SUBJECT: Forwards response to NRC 791024 ltr re dedicated safe shutdown sys. Onsite power supply & possible new or rerouted bus work undergoing engineering analysis. Final design will be submitted by 800301.

H. B. ROBINSON STEAM ELECTRIC PLANT, UNIT NO. 2

RESPONSE TO QUESTIONS REGARDING SAFE SHUTDOWN CAPABILITY

The attached correspondence contains CP&L's response to information requested in your October 24, 1979 letter titled "Staff Position-Safe Shutdown Capability" concerning the Robinson dedicated shutdown system.

FIGURE 10
EMERGENCY DC POWER SUPPLY

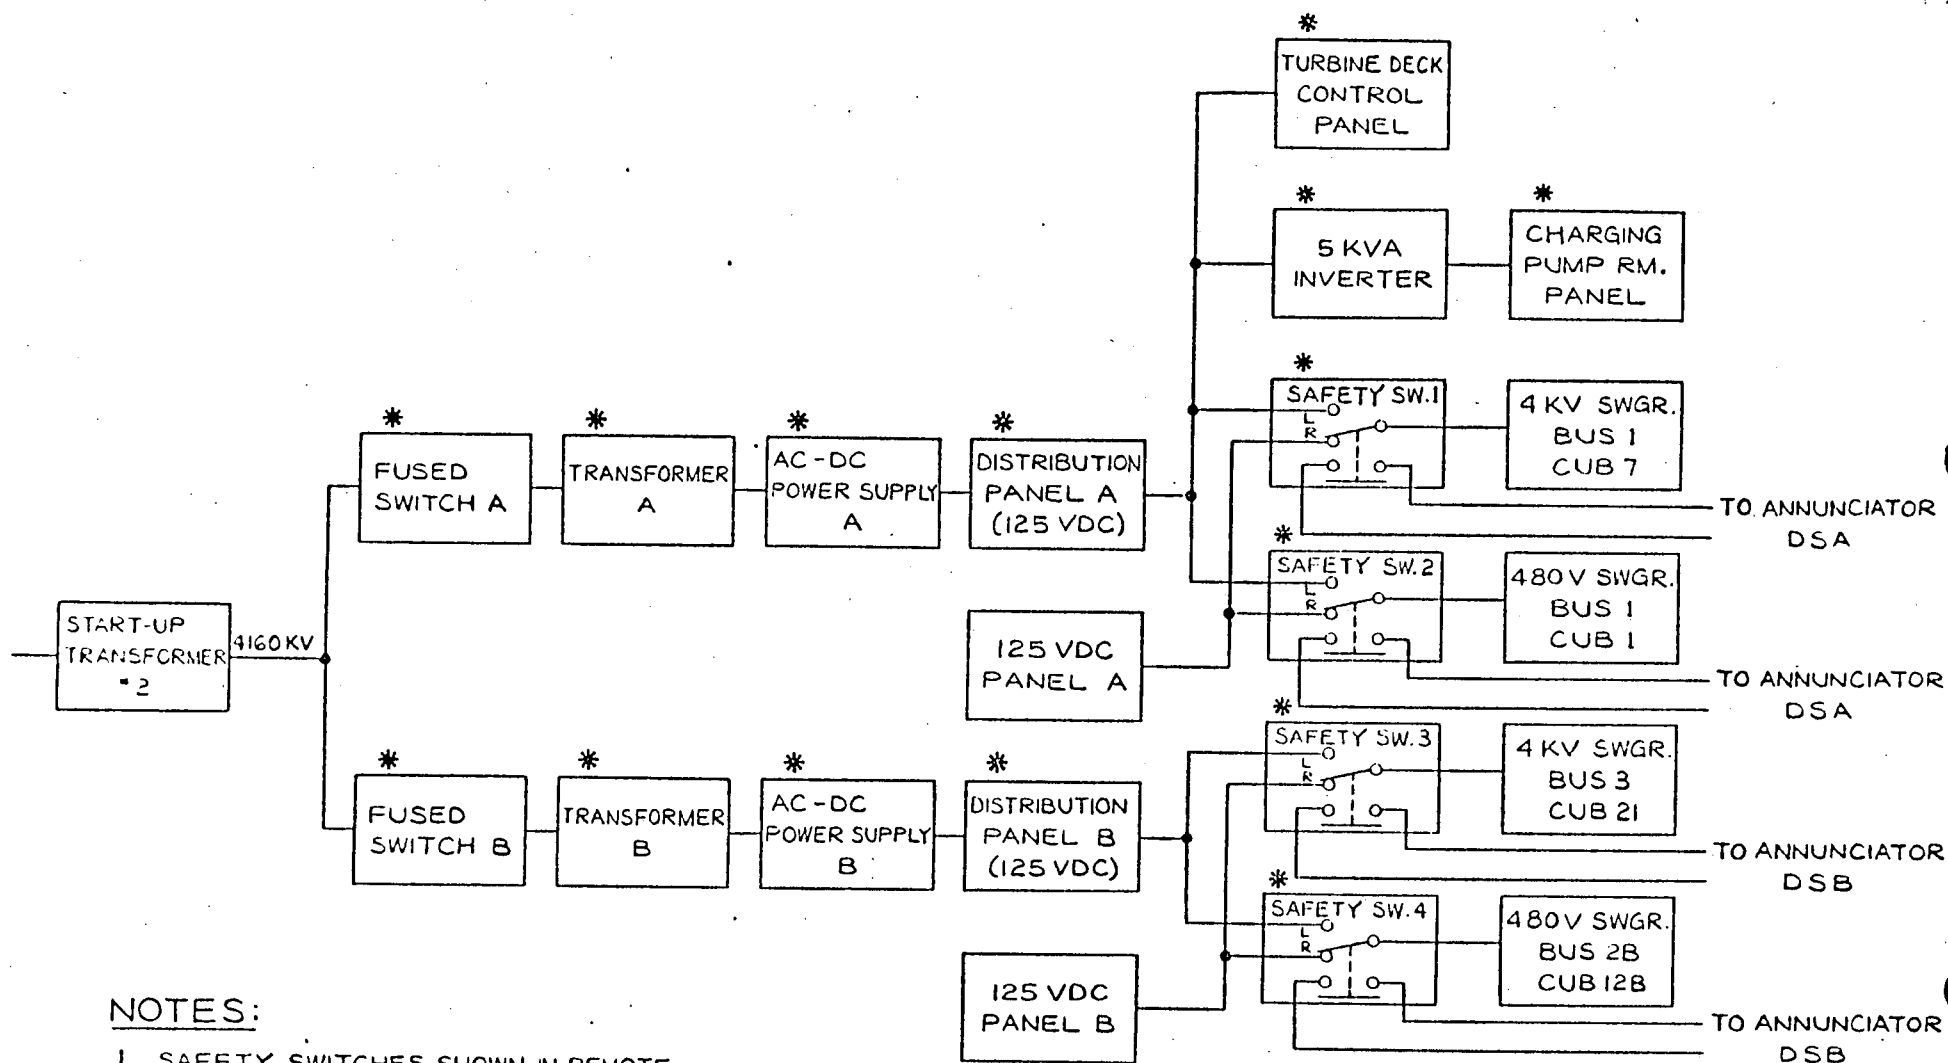
Emergency DC Power Supply/Dedicated Shutdown Instrumentation

The modification provides an alternate DC control voltage source to the emergency switchgear. Figure 10 depicts the alternate supply transfer and emergency switchgear alignment. The new distribution panel B provides an alternate DC control voltage source to 4kV buses 3 and 4 via interconnections with bus 3 cubicle 21 and to 480V buses 2B and 3 via interconnections with bus 2B cubicle 12B. The new distribution panel A provides an alternate DC control voltage source to 4kV buses 1 and 2 via interconnections with bus 1 cubicle 7 and to 480V buses 1 and 2A via interconnections with bus 1 cubicle 1. The transfer to the alternate 125 VDC control voltage source is annunciated in the Control Room. In addition, the new 125 VDC panel A supports a 4KVA inverter located outside of the emergency switchgear room, in the 4KV switchgear room. The inverter supports dedicated shutdown instrumentation which is located in the charging pump room control panel. The dedicated shutdown instrumentation provides the following local displays at the charging pump room panel:

It should be noted that the emergency DC power configuration shown on Figure 10 is based on the assumed availability of offsite power. In the event of a fire in the battery room (or cable spreading room) coincident with a loss of offsite power, a complete loss of site DC power may be experienced. The main consequence of this failure would be the inability to operate circuit breakers to line up alternate power sources (most breakers are DC-operated).

To mitigate the consequences of this potential situation a backup onsite power supply will be provided to power the shutdown-related loads. The breakers supplying the shutdown loads will be either manually operated or electrically (AC) operated. In accordance with Appendix A of BTP 9.5-1, the onsite power supply and the associated switchgear and appurtenances will be designed and procured to non-seismic Category I criteria, and will not be designed to meet single-failure criteria. This onsite power supply will be provided by October 31, 1980.

FIGURE II
SWITCHGEAR MIMIC PANEL CONTROLS

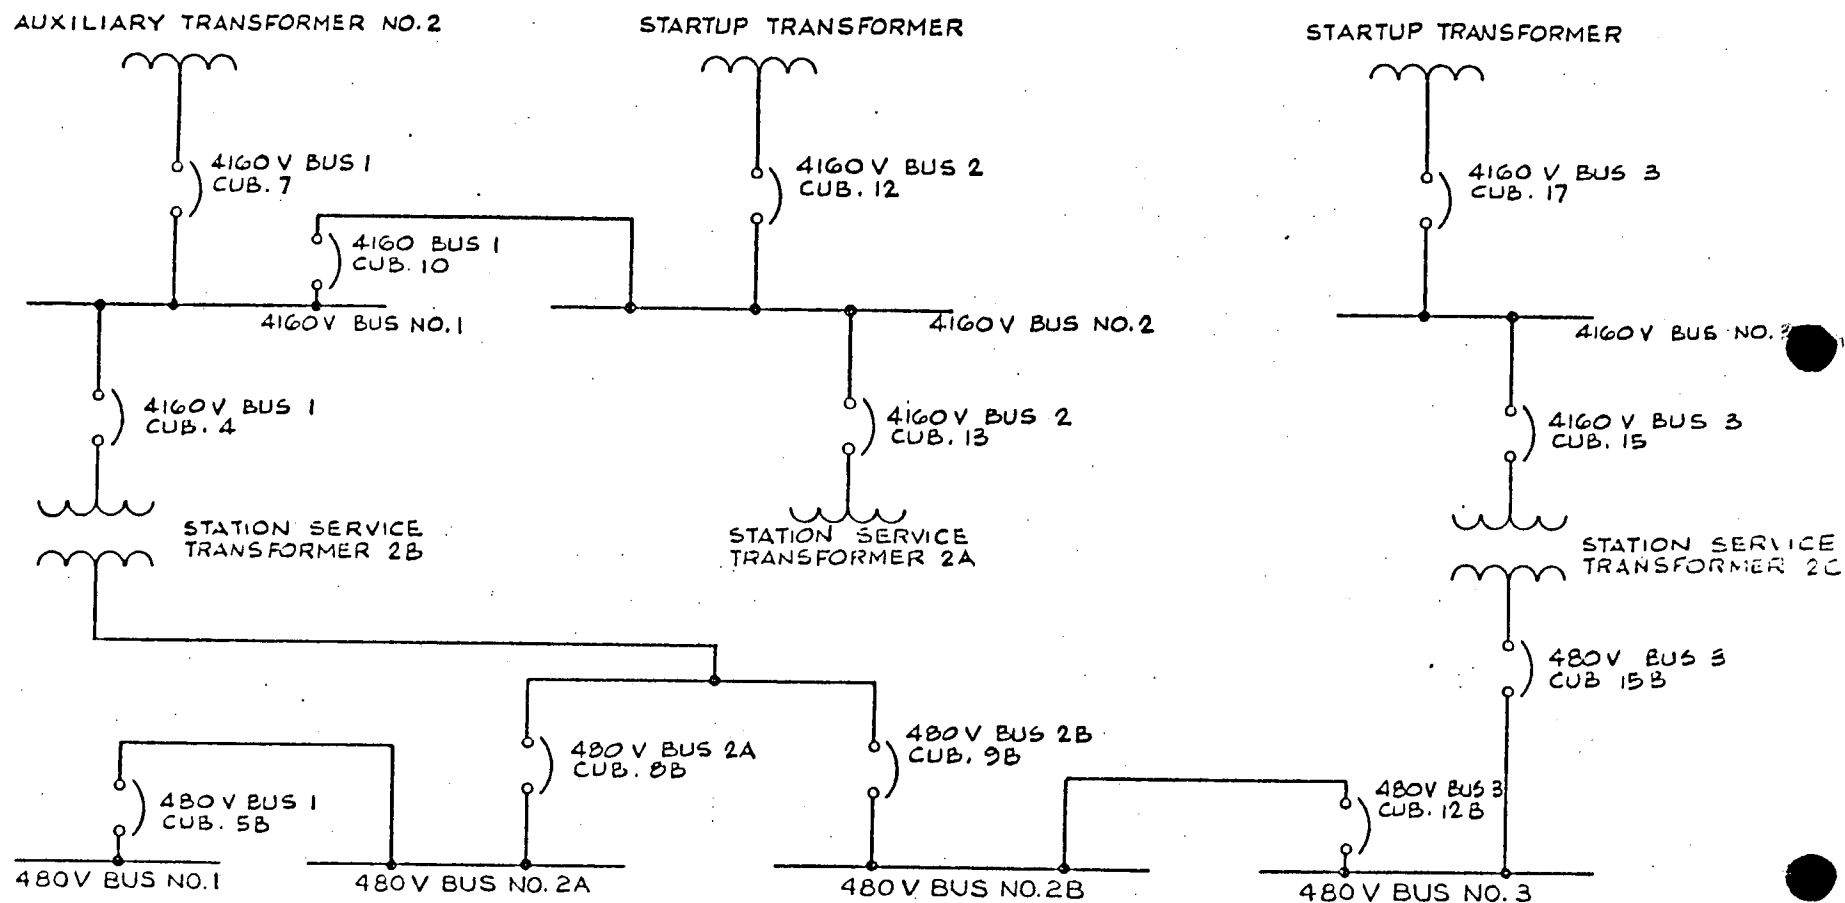
Switchgear Mimic Bus Control Panel

Figure 11 is a single-line diagram showing the breakers affected by this modification. All control transfer and selector switches associated with these breakers are located on the mimic panel, located in the 4160V switchgear room. Each breaker control circuit is configured as shown on Figure 11. The transfer of breaker operation to local control is annunciated in the main Control Room.

It should be noted that Figures 10 and 11 describe the mimic bus panel as presently configured. The installation of the onsite power supply and its associated switchgear may require that minor changes be made to this panel in order to facilitate proper alignment of the alternate power sources when needed.
